# CITY OF ALBUQUERQU

Midtown Storage Units-Phase 1 Re:

Request for Permanent C.O. - Accepted Engineer's Stamp dated: 4-19-16 (H17D105)

## MIDTOWN SELF STORAGE EXPANSION GRADING AND DRAINAGE PLAN

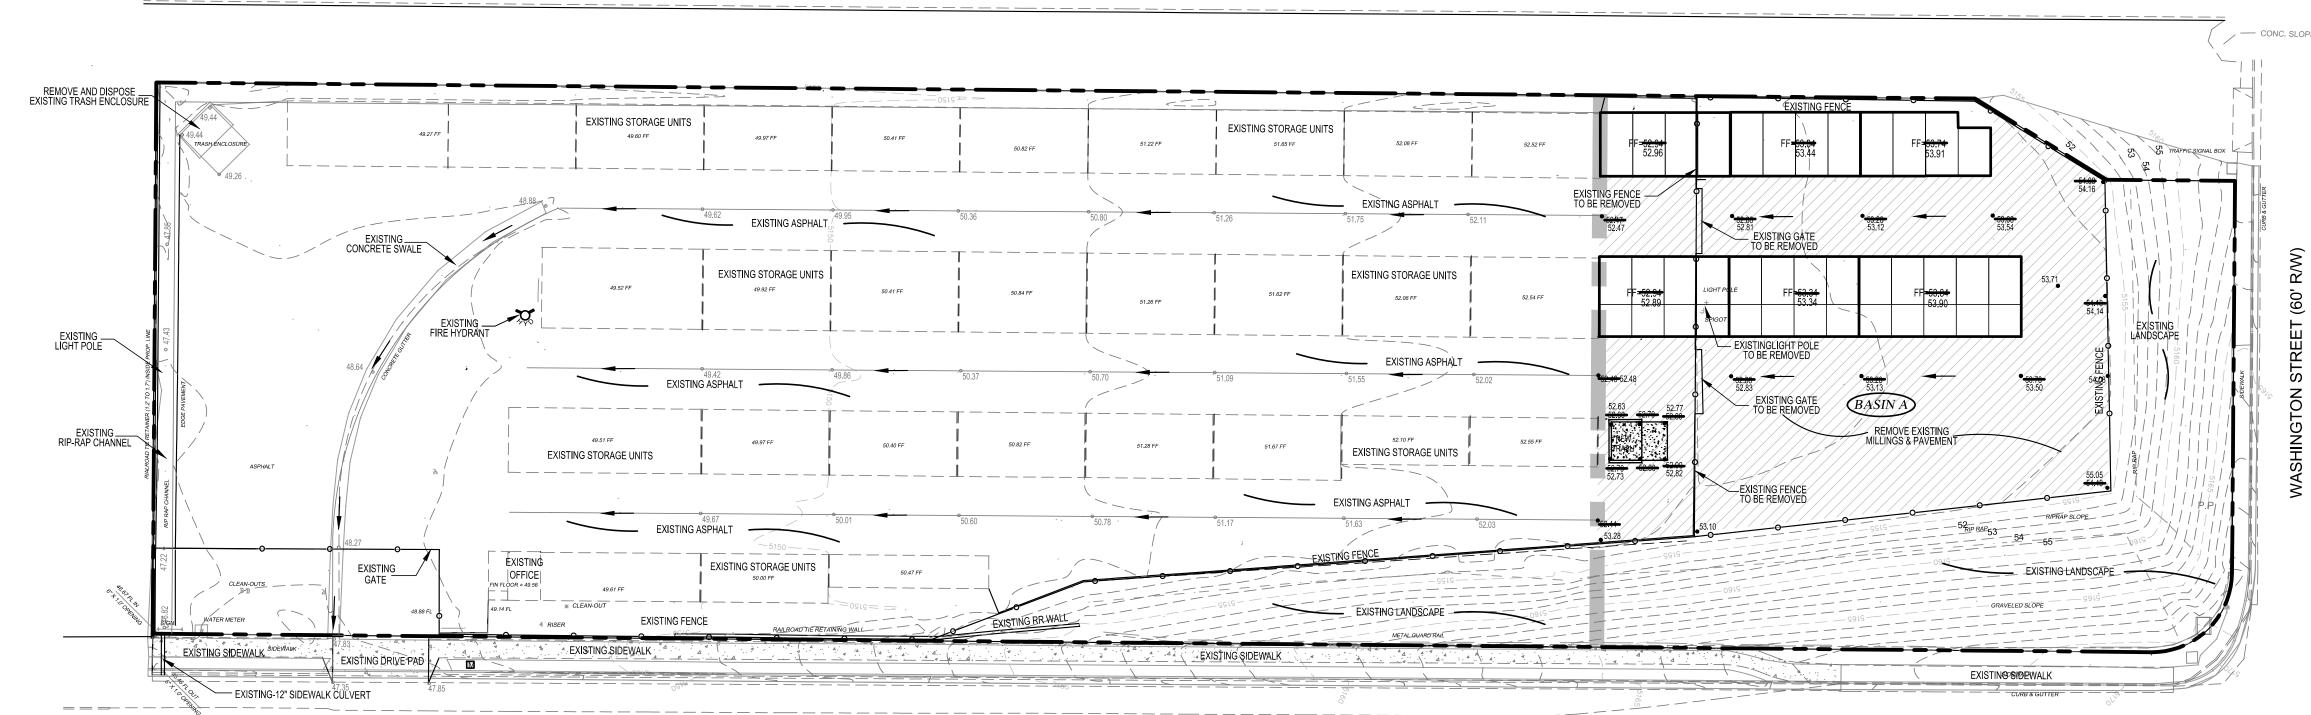
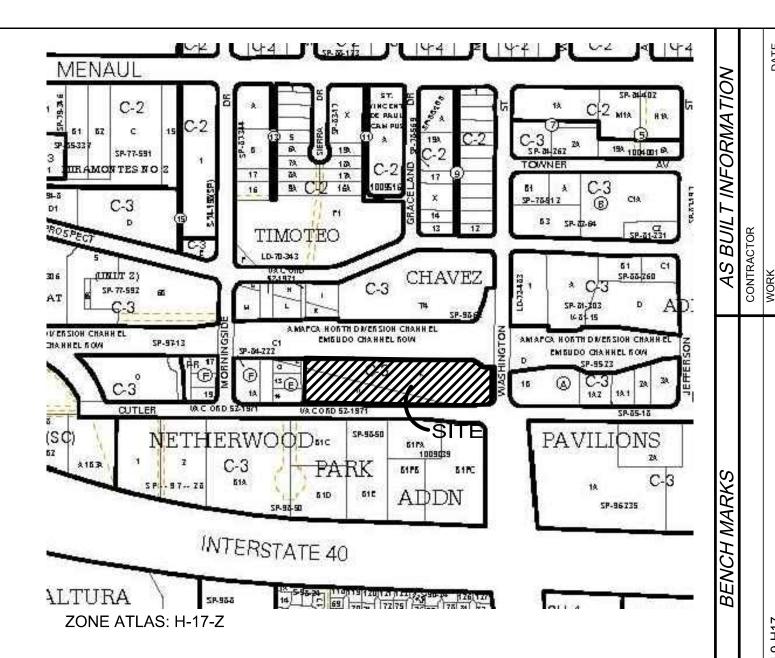
Based on the Certification received 9/21/2016 and photos received, is acceptable for permanent Certificate of Occupancy by Hydrology.
